CHESTER ACADEMY STEM LAB ALTERATIONS
CHESTER UNION FREE SCHOOL DISTRICT
BID ADDENDUM #1
11/16/2022

Sheet Title
TEMPORARY FACILITIES & LOGISTICS
S.E.D. Control No. 44-02-01-02-0-009-006

Sheet No.
ASK - 01

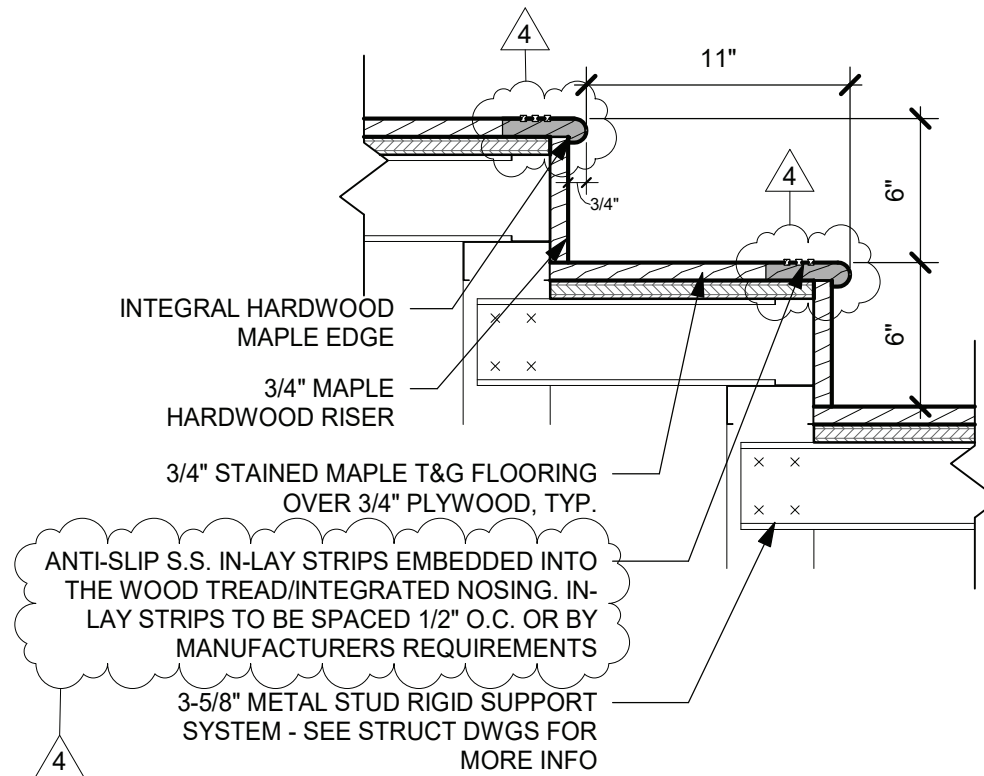
CONSTRUCTION PERSONNEL TO COORDINATE WITH OWNER ON PORTION OF NORTH-WEST PARKING LOT FOR TEMPORARY FACILITIES. INCLUDING BUT NOT LIMITED TO TRAILERS, CONSTRUCTION TOILETS, WORKER PARKING, STORAGE, ETC.

LOCATION OF TEMPORARY BUILDING ACCESS FOR CONSTRUCTION PERSONNEL. TEMPORARY BUILDING ACCESS INCLUDES SCAFFOLDING TO 2ND FLOOR WINDOW WHERE GLASS PANEL IS REMOVED FOR TEMPORARY ENTRY ACCESS PANEL.

LOCATION OF DUMPSTER(S) WITH REQUIRED FENCING. NOTE: THIS IS AN EXISTING GRASS AREA, UPON COMPLETION OF PROJECT RESTORE AREA TO ITS EXISTING CONDITION.

- WINDOW (AT DESIGN COLLABORATION - 201A) IS TO BE USED AS THE TEMPORARY BUILDING ACCESS POINT.
- GC IS TO CAREFULLY REMOVE AND STORE MIDDLE WINDOW PANE AND REPLACE WITH AN ENTRY ACCESS DOOR.
- THIS ACCESS IS TO BE USED DURING SCHOOL HOURS.
- UPON COMPLETION OF WORK, GC IS TO REINSTALL WINDOW PANE TO COMPLY WITH WINDOW REQUIREMENTS.
- GC TO PROVIDE SCAFFOLDING UP TO THE 2ND FLOOR WINDOW
- PROVIDE SMALL STAGING AREA ADJACENT TO SCAFFOLDING AS REQUIRED FOR LOADING QUEUE. ENCLOSE ENTIRE AREA WITH THE REQUIRED FENCING.
- ALL EXISTING WINDOWS ARE TO BE PRESERVED AND PROTECTED DURING CONSTRUCTION.
- REMINDER, STAIR B CAN BE USED TO ACCESS CONSTRUCTION AREA WHEN APPLICABLE. COORDINATE WITH OWNER.
